ADDENDUM #4

RFP #7670815

TITLE: Design Build Services for East Bay Bike Path Bridge Replacement

RFP #7670815 – DESIGN BUILD SERVICES FOR EAST BAY BIKE PATH BRIDGE REPLACEMENT
(REQUEST FOR PROPOSALS)
ADDENDUM #4
SUBMISSION DUE DATE: April 1, 2022 at 11:00 am

EAST BAY BIKE PATH
HIGHWAY
BARRINGTON/WARREN
RHODE ISLAND
GENERAL PLAN

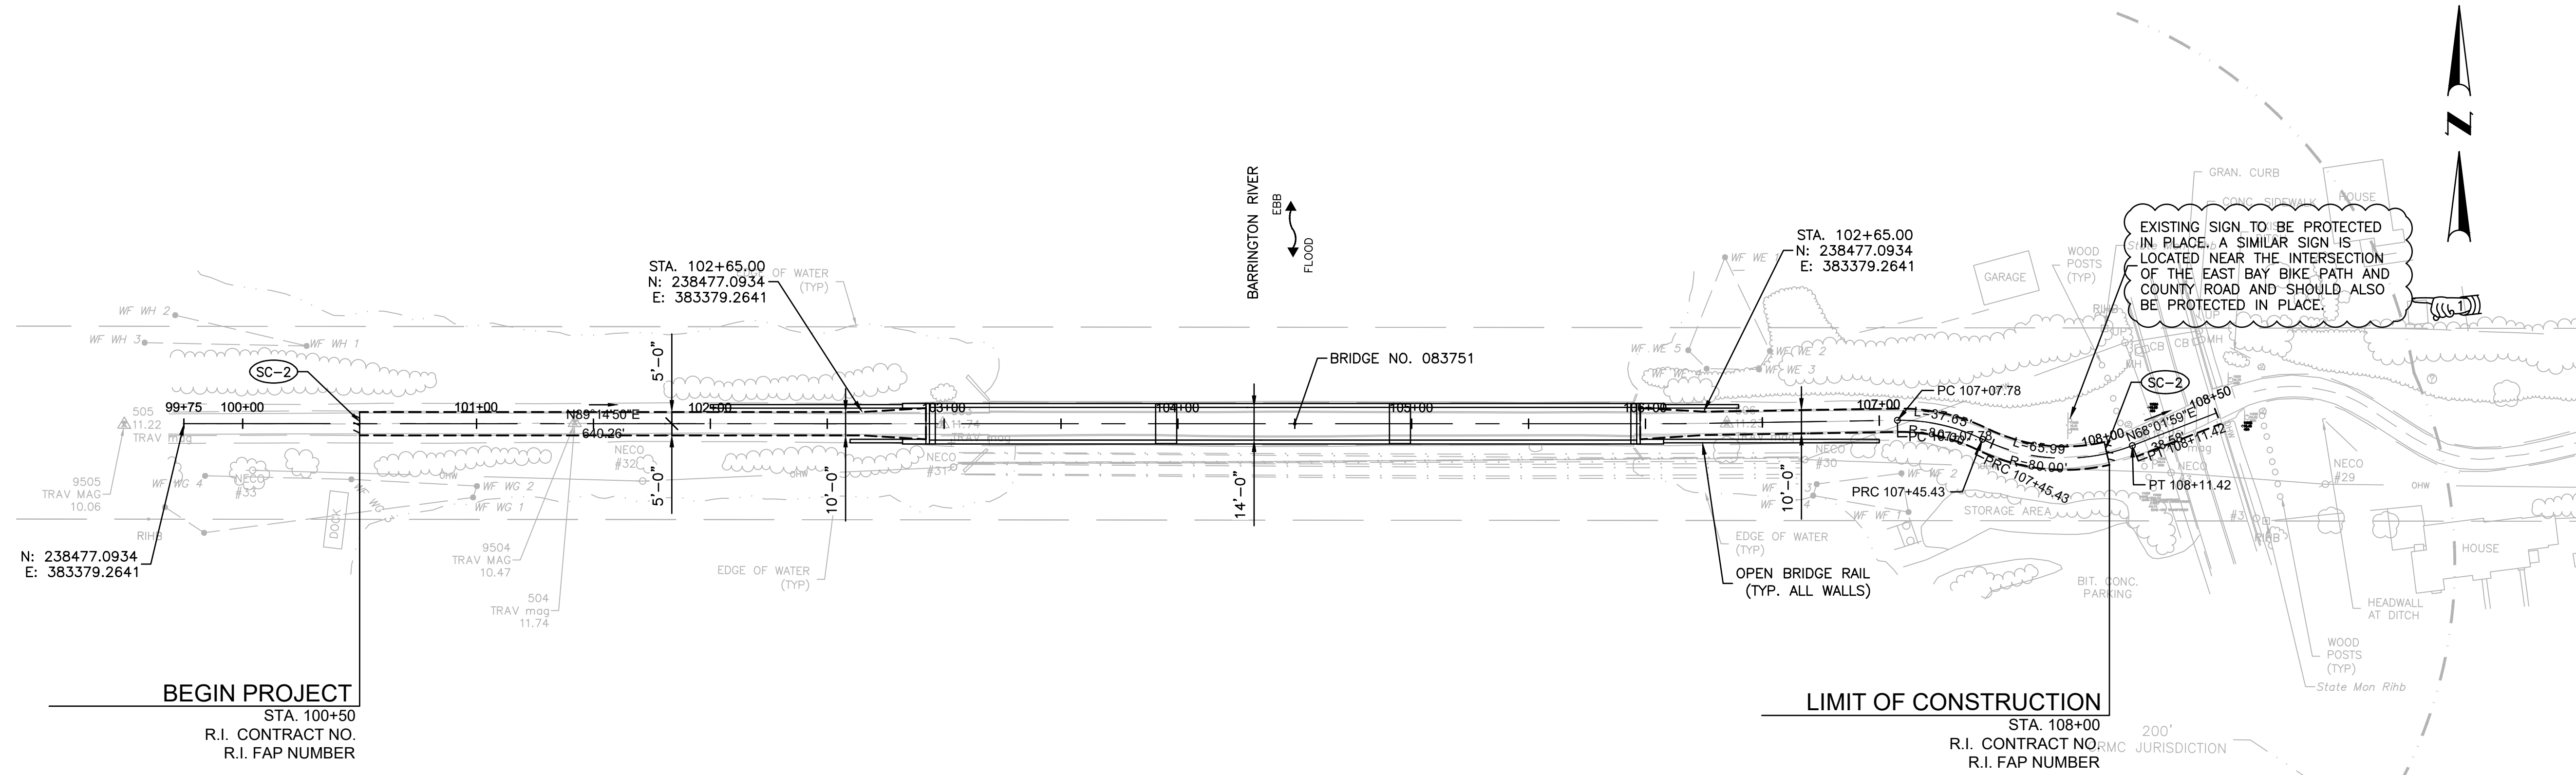
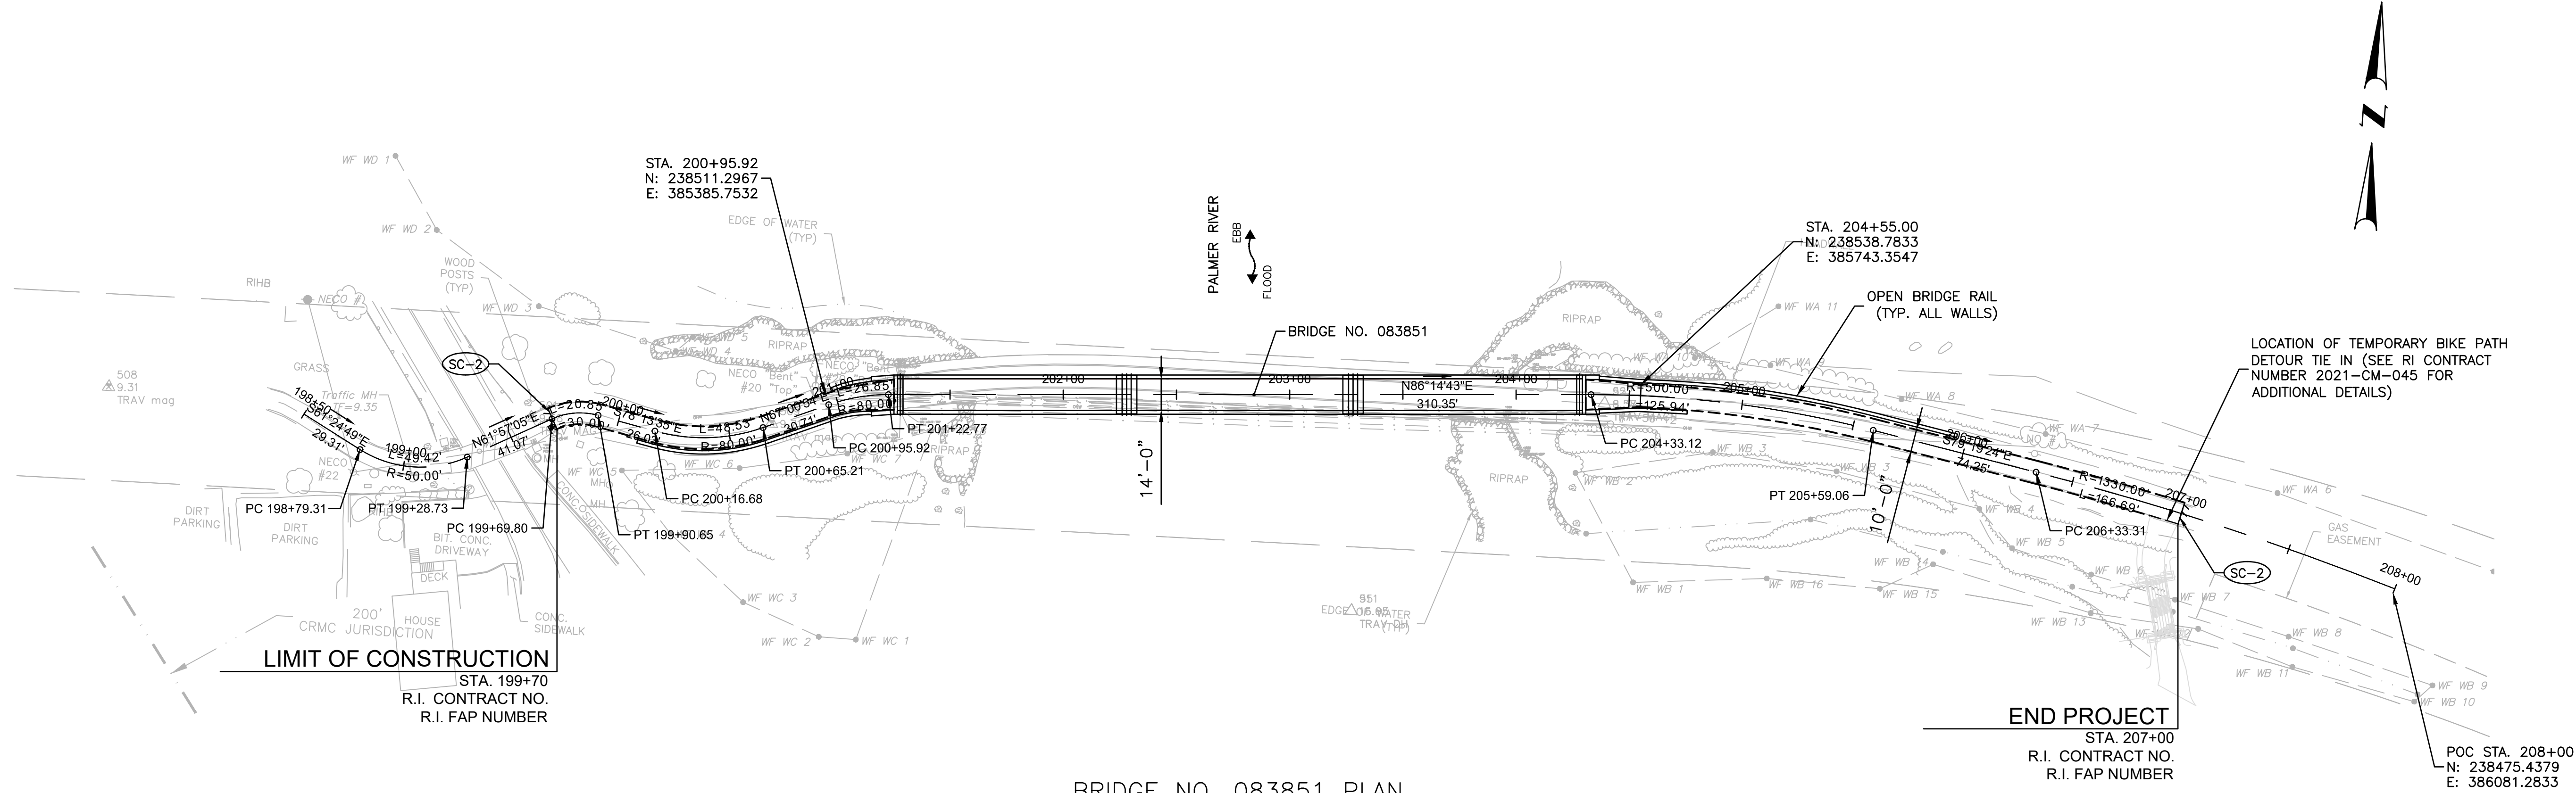
1. BTC Plans Additional callout added to Sheet No. 6 – General Plan.
2. Appendix B.06 Added GIRs
3. Appendix B.11 Added Pictures of Historically Significant Signs
